#### REMARKS

#### A. The Remaining Objection to the Drawings

FIG. 1

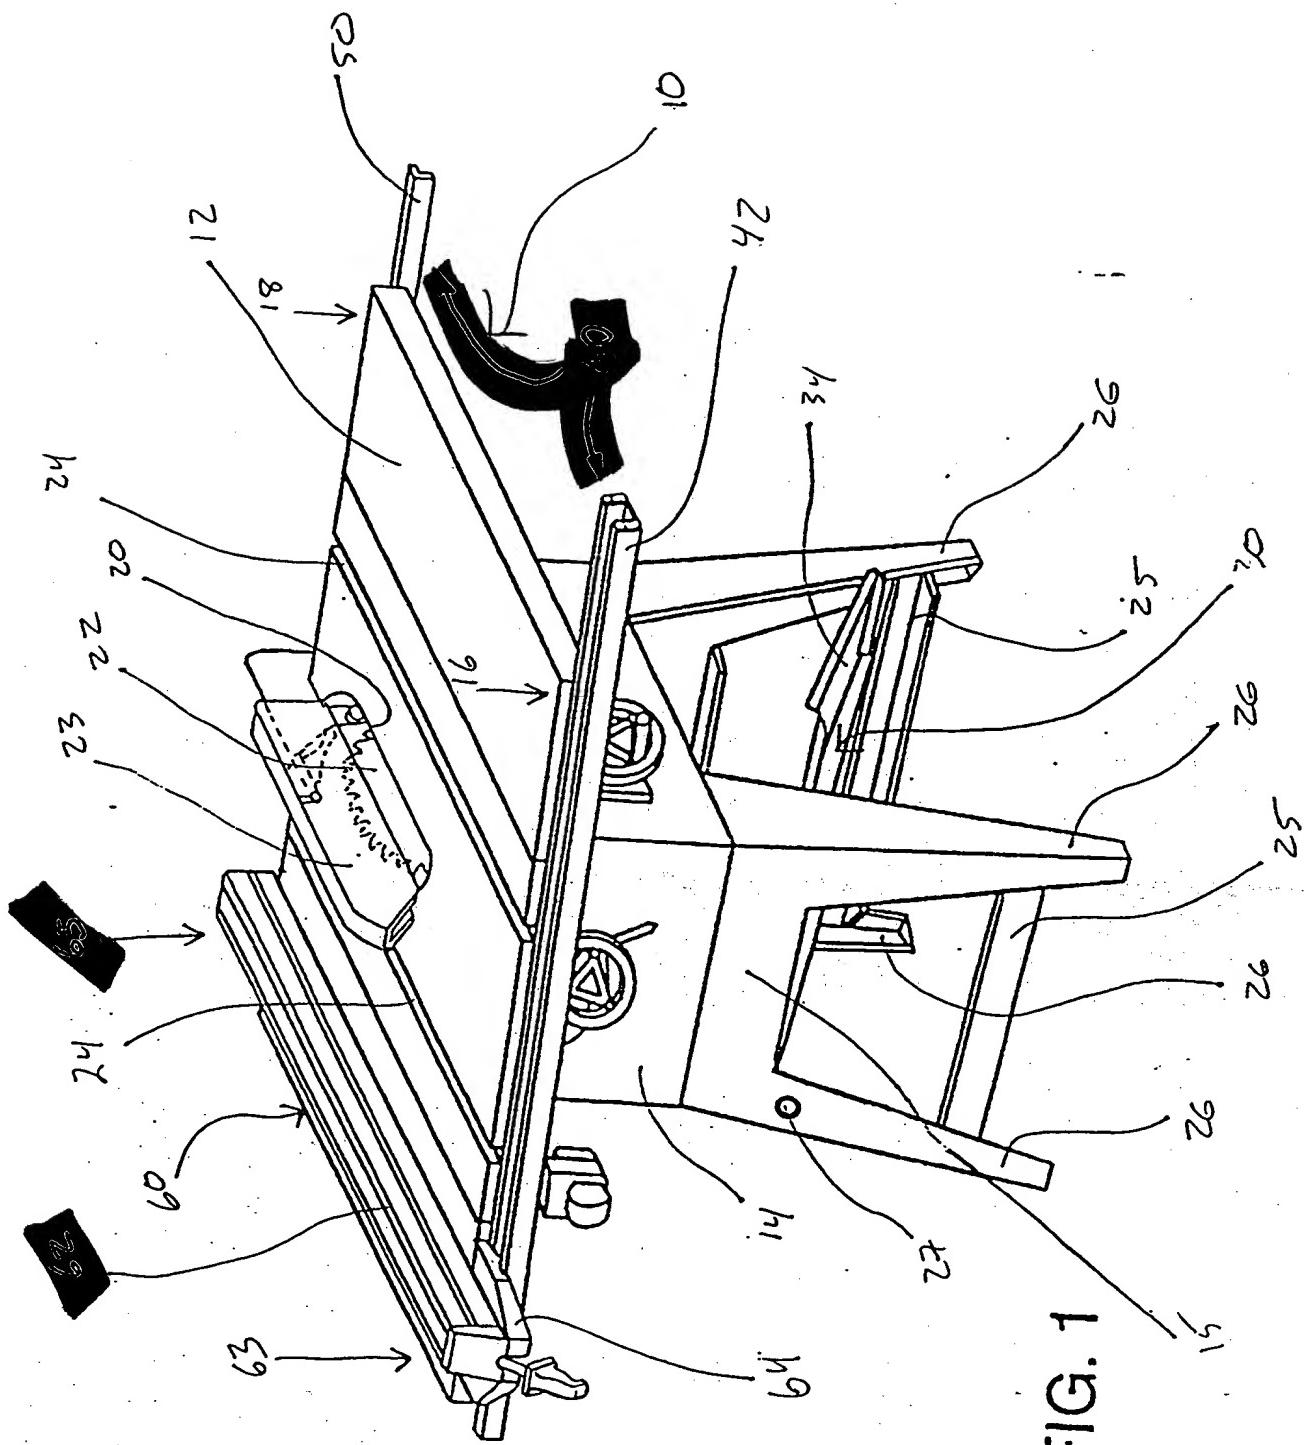
In paragraph 2 of the Office Action, the Examiner has indicated that the proposed substitute sheets of drawings, filed on September 7, 1999, were approved-in-part. Proposed drawings changes to Figures 2, 13, 15 and 16 were approved. The changes to Figure 1, however, were disapproved. Applicants herewith submit a replacement Figure 1 complying with the

Examiner's current requirements. The replacement figure correctly indicates the location of body 62 and outfeed end 65, and adds numeral 40 to indicate the rail system.
